From: Griffin, Tim (Contractor)
Sent: 19 February 2026 17:58
To: Altman, Rebecca
Cc: Oliveira, Marta (Contractor); Dyer, Tim; Ellison, Mark
Subject: RM/25/100615 Land West of Burnetts Lane (The Holme and Homestall), Horton Heath, Eastleigh, SO30 2HH - landscape comments

I have been asked to provide landscape comments on this reserved matters application.

Foxwood Road

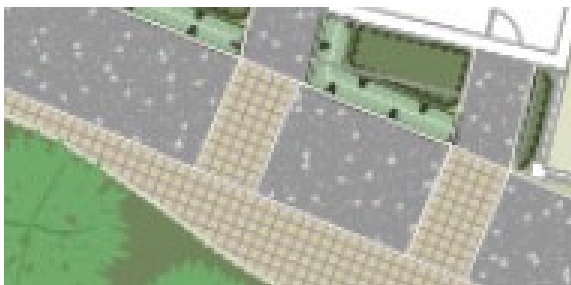
7/ This is not the easiest area to assess as some areas are offsite to Holme and the junction is very odd, cutting 1/2 way through spaces that should really be considered together.

Generally the streetscene lacks coherence with a range of different landscape effects proposed. Tree planting is limited and sporadic, and in places the trees lie too close to the proposed dwellings which will restrict these to only small trees.

The layout of the tree planting shown just offsite along the edge of the main open space is questionable. Can it be delivered? In places the trees are shown planted in very narrow planting strips. A continuous avenue of trees along this edge would have been more effective.

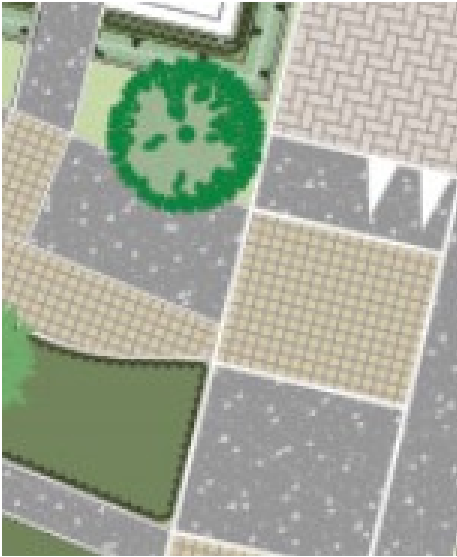
Please clarify purpose of sweeping bays of paving alongside the cycle path:

Is this intended for seating or cycle racks or perhaps purely decorative?

Fir Tree Lane Linear Park

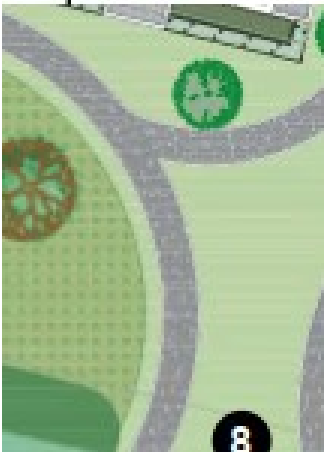
I welcome the nature-focussed approach and the 'play on the way' and outside exercise elements.

Is the indicated SuD's pond and ditch existing? If so, are these going to be lost under existing vegetation cover.

Hardscape & Furniture Palette

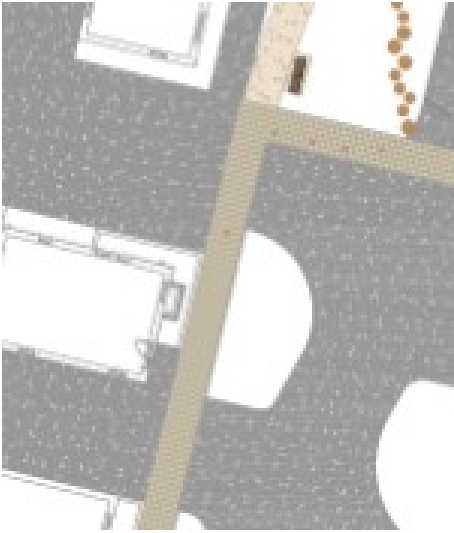
18/ Generally acceptable, although various surfacing types to be indicated on the landscape masterplans.

Increase areas of block paving in parking courts where limited opportunities for tree planting to lift quality of spaces.

Maintenance access route - replace grasscrete with Bodpave85 plastic grids filled with topsoil and grass seeded.

I suggest the cycleway to be coloured bitmac for added quality.
